Annual Performance Report 2016/2017

The changes we have made

December 2018

This document summarises the changes we have made to our Annual Performance Report (APR) since its first publication on 13th July 2018. You can find our updated APR on our reports page **yorkshirewater.com/reports**

Change 4 Correction

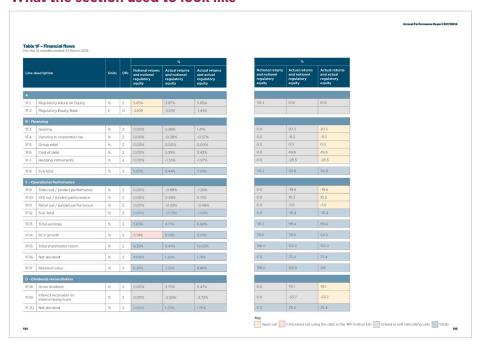
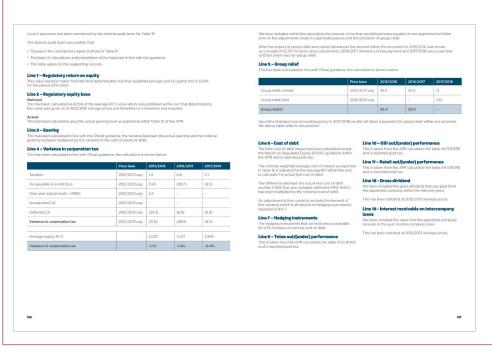
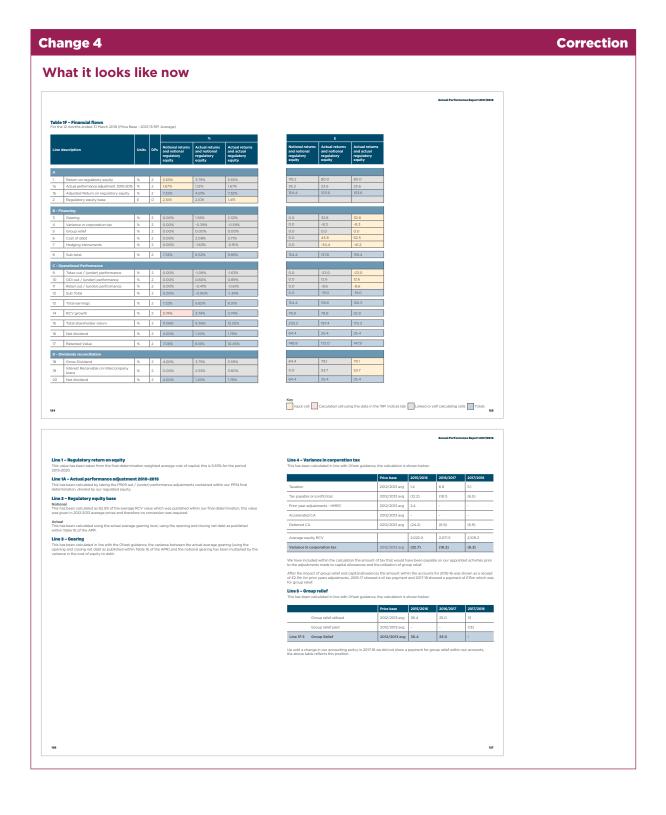
An older version of the financial flows table (table 1F) and associated guidance was used.

We have updated our financial flows table to include lines 1a and 1b and followed the updated guidance.

Change 11 Correction

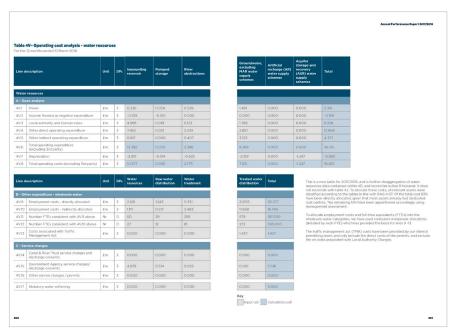
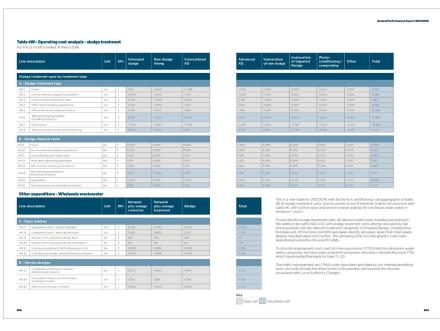
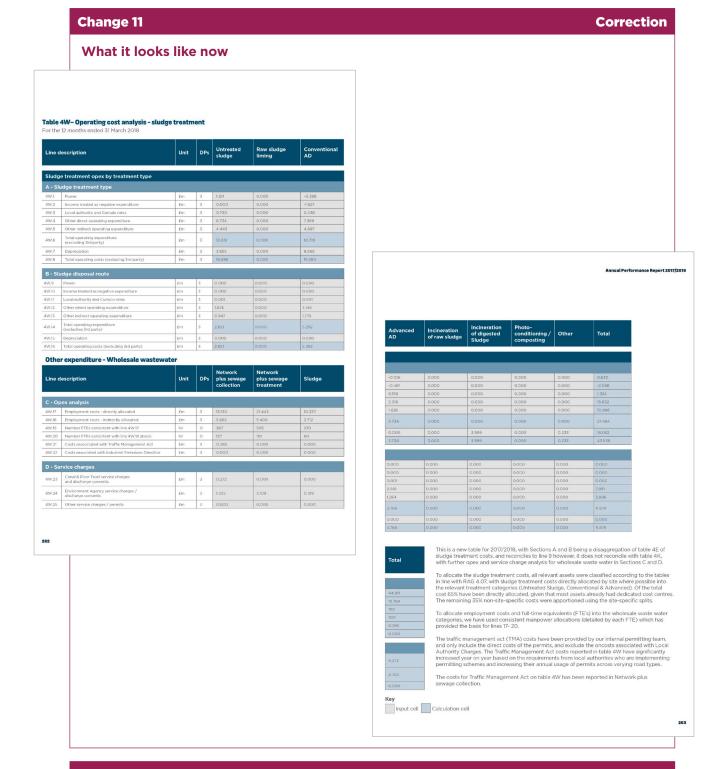
There was a negative Historical Cost Depreciation (HCD) figure in line 7 of tables 4V and 4W. This is expected to be entered as a positive number.

We have updated our HCD figure in tables 4V and 4W converting the negative depreciation figure to a positive figure.
